*Second Regional Information Sharing on Pak Lay Prior Consultation Process*

## **Second Draft Technical Review on Sediment & River Morphology**

**Dr. Nguyen Duc Tuan, Water & Climate Monitoring Specialist, MRC Secretariat**

*Comparison of monitoring GS results and developer's results*

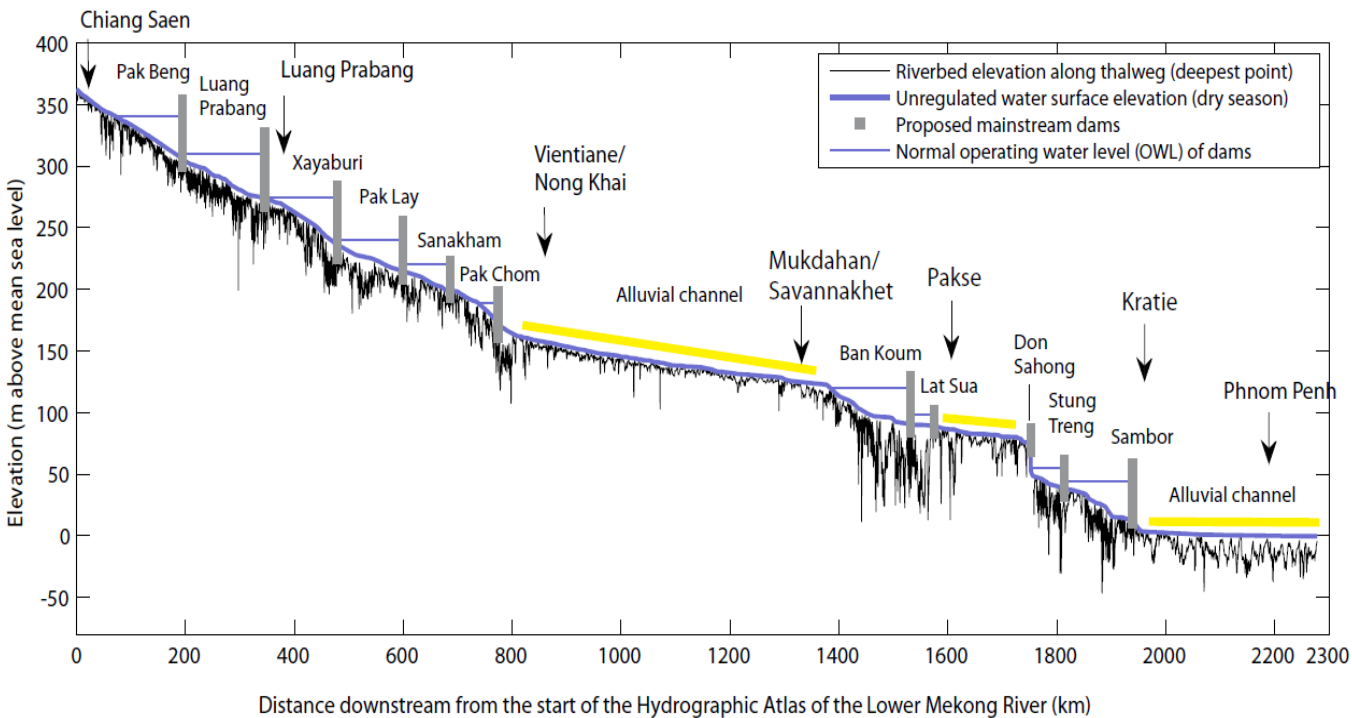
- Data consistent with MRC monitoring results and present understanding
- On-going monitoring is commended but larger data set is required
- Need to consider potential changes between dam site and Chiang Khan (~112 km)
- Grain-size information is limited to only a few samplings over a short period
- Percentage of sand reported by developer is considerably less than reported at Luang Prabang or Nong Khai in MRC coordinated sediment monitoring program
- **Under-estimating sand in sediment load will affect sediment trapping predictions and sediment flushing modelling**

### Review of infrastructure

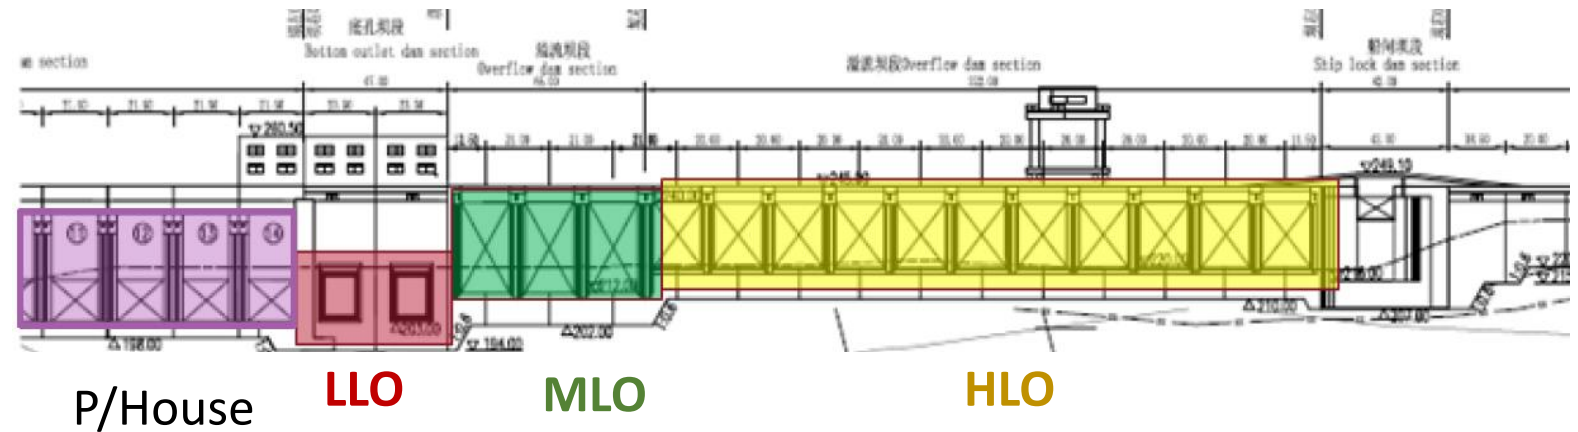
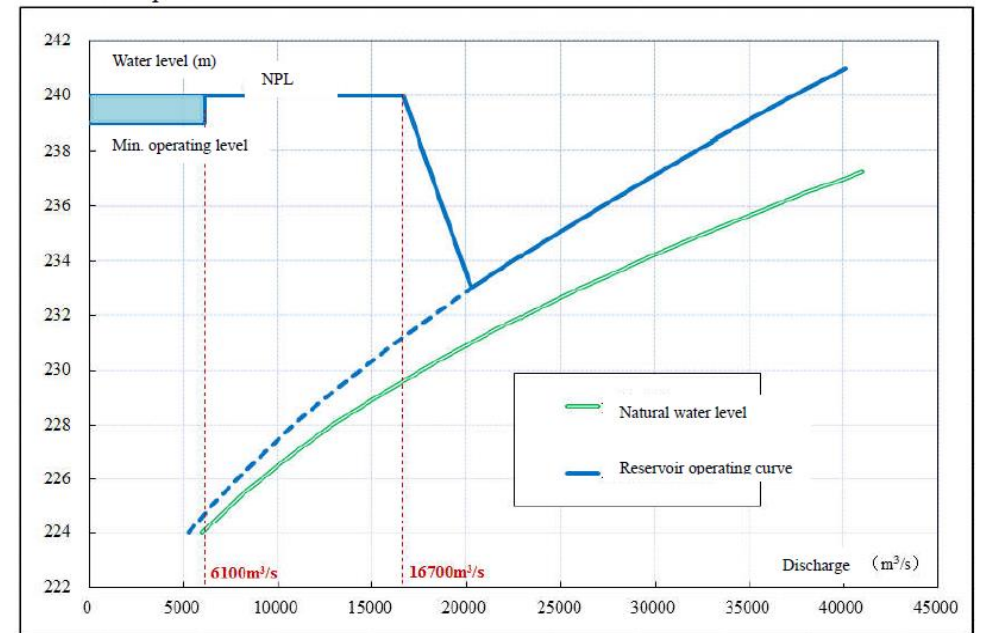
- Small surface area for passing sediments-only 200 m<sup>2</sup> cf. 768m<sup>2</sup> at Xayaburi
- Small size limits ability to flush sediments resulting in large deposition within ~60 m of dam
- No quantification of sediment flushing through LLOs or MLOs
- No model runs optimizing sediment flushing as function of flow & drawdown rate

### Review of modelling

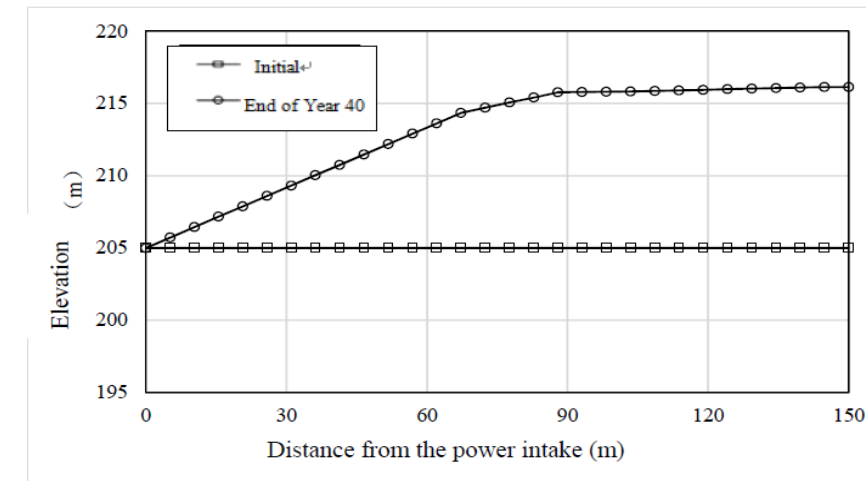
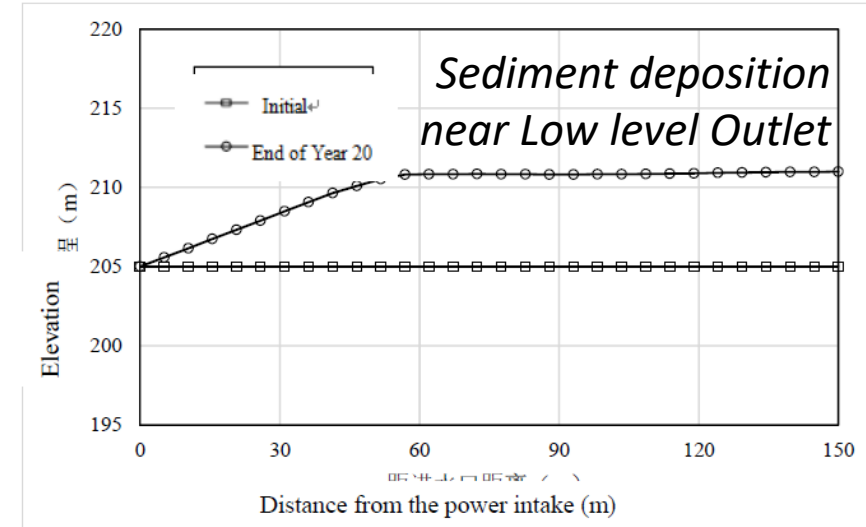
- Lack of information about models used, parameterization and calibration. Lack of justification for parameters extracted from other river models & no discussion of model error
- Lack of comparison between numeric and physical model results
- Sensitivity analyses did not include higher proportion of sand in sediment load (only higher total sediment load). 1-D will not accurately capture sediment trapping in all areas of impoundment
- Need to be updated using results from longer term monitoring data set
- Models should be used to optimize sediment flushing
- Need to include a map showing the alluvial banks downstream locations that will be susceptible to erosion.
